**Ref: 29 New End
Response to GMA queries**

Please find enclosed our response to Campbell Reith's queries regarding the Ground Movement Assessment completed for the proposed 29 New End project. Specifically, these responses refer to the queries outlined in Paragraphs 4.7 and 4.8 of the Basement Impact Assessment Audit (revision D1).

Figure 1: Select SPT-N60 profile

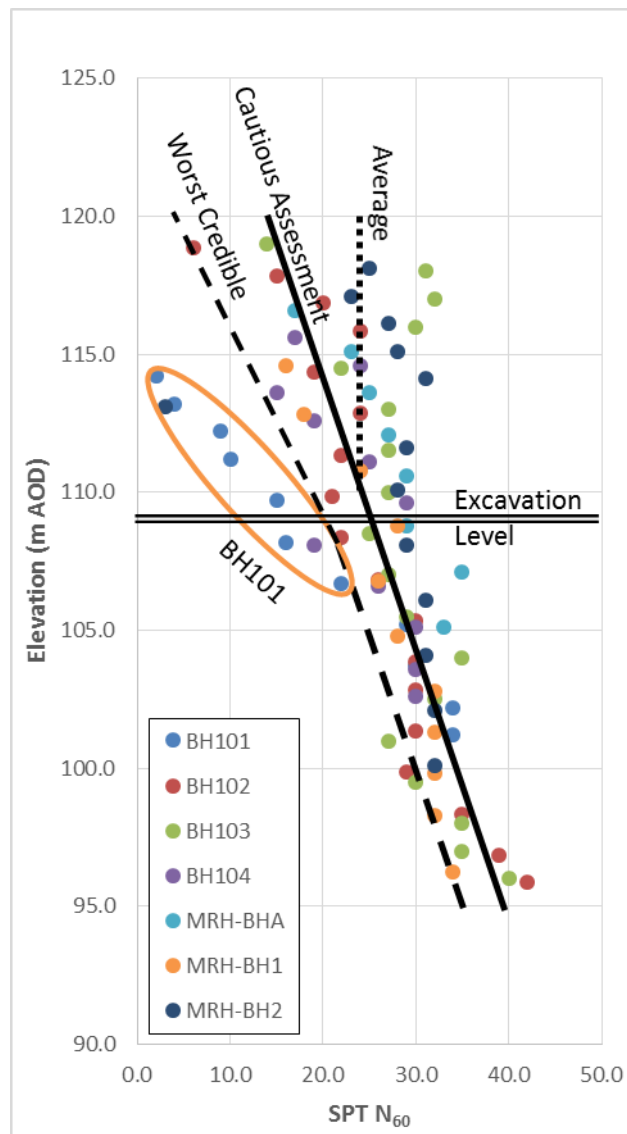
Item 3: Justification for the assumptions made in the GMA regarding stiffness of cohesive strata is required with confirmation that the SPT N60 design profile represents a 'cautious' assessment;

Figure 1 provides a review of the SPT N_{60} results used to develop the adopted design profile. It is considered that the adopted design line presents a cautious assessment of the variation of SPT N_{60} with elevation, particularly with regards to the results within the retained height of the excavation. Notably, BH101 tended to indicate a lower trend, though it was considered to be an outlier for the assessment.

The drained Young's modulus of the cohesive Claygate Beds was assumed to be approximately 50 MPa at the surface (circa +102m AOD, approximately 17m below ground surface at the Lawn House section) and increasing at a rate of 2 MPa per meter. This was considered to be a conservative estimate of the stiffness of these beds, which makes an allowance for the anticipated level of strains in the retained ground mass in typical operating conditions.

The undrained shear strength of the clay may be approximated based on SPT blow counts as, $s_u = 5 N_{60}$ (in kPa). A typical rigidity index for overconsolidated clays in London, which allows for small strain levels at working conditions behind the retaining wall is $E_u/s_u = 500$. The SPT N_{60} at the top of the beds is approximately $N_{60} = 30$ and increasing at a rate of approximately 1 N_{60} /m. Thus, based on the preceding discussion, the adopted drained stiffness profile is conservative and nominally 10 MPa less than what could be taken at face value from the available data. The adopted stiffness profile is considered to be cautious in this respect.

Figure 2: Damage category on the assumption of a “Low Stiffness Wall” at Lawn House.

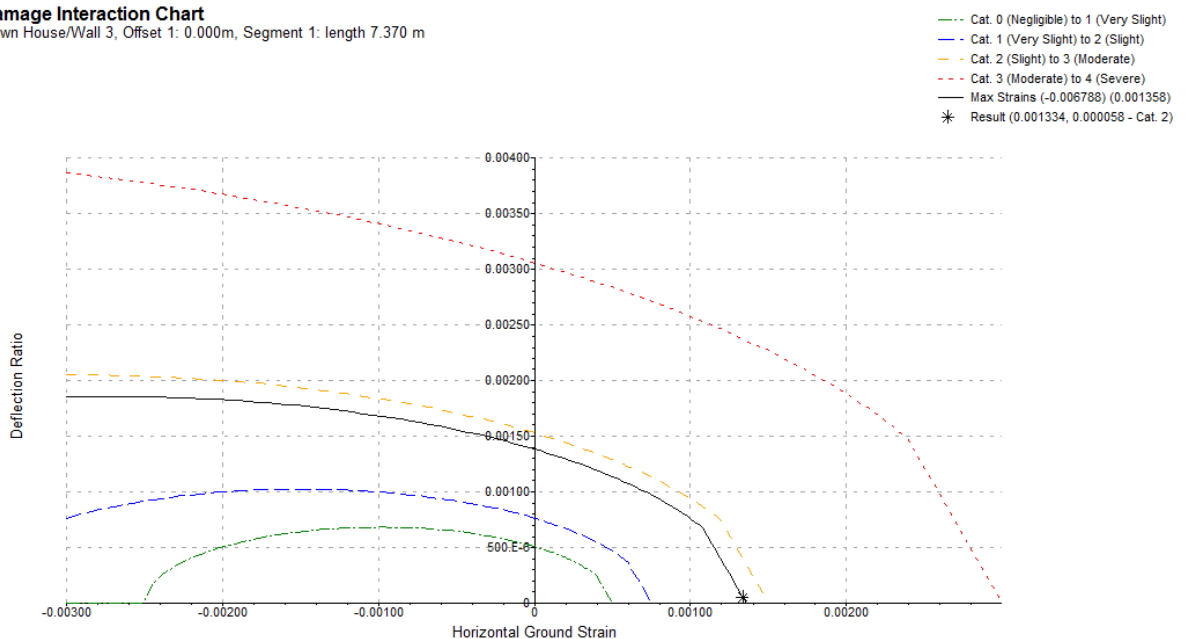
Item 6: It is noted that the proposed retaining walls in east-west direction, i.e. adjacent to Lawn House and Christ Church Cottage, are not retained by any structural element, and thus, form cantilever walls of up to 6.5m high. The GMA assumes excavation in front of a 'high-stiffness' wall which would require them to be propped at all times.

Notwithstanding the above, a simplified sensitivity check on the effect of adopting a “Low Stiffness” wall was assessed as part of the GMA for Lawn House. As shown in Figure 2, the maximum predicted Damage Category is Category 2 – Slight. This is within the existing maximum damage category assessed for Lawn House, albeit the position of the damage category coordinate is located further within the Slight damage contour interval.

Figure 3: Damage Category at Lawn House based on full secant pile installation effects. Overall damage category does not change from existing GMA damage category.

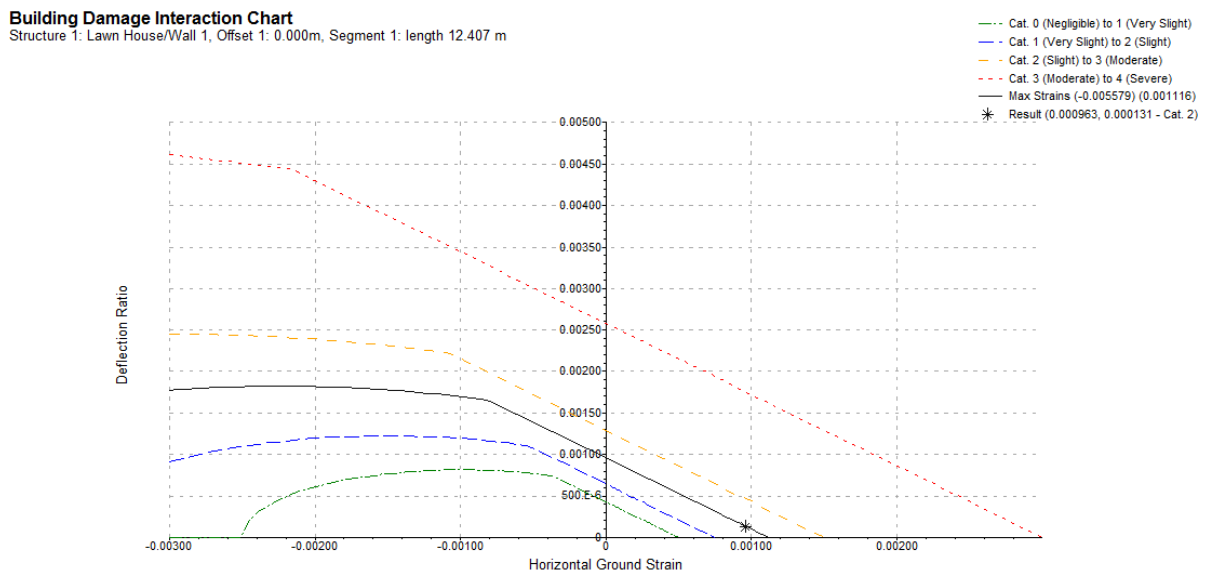
Item 7: It is noted that the GMA uses the assumption of ‘contiguous piled wall’, whilst the proposed construction consists of ‘secant’ walls that are known to exhibit larger ground movements. It is not considered that this represents a ‘cautious assessment’.

Notwithstanding the above justification, sensitivity analyses were carried out to assess the damage category predicted at Lawn House if the full secant pile installation effects were adopted for the analyses. The sensitivity analyses indicate that the Damage Category for Lawn House (previously identified to be the most critical structure in terms of building damage category) remains within the predicted Category 2 – Slight range (Figure 2). Albeit, whereas previously the damage category identified in the GMA was estimated to be straddling the Category 1/Category 2 boundary, the damage coordinate is now centred within the Slight damage range. Nevertheless, there does not appear to be orders of magnitude differences in ground strain and thus building damage, due to the selection of a much more conservative pile installation effect.
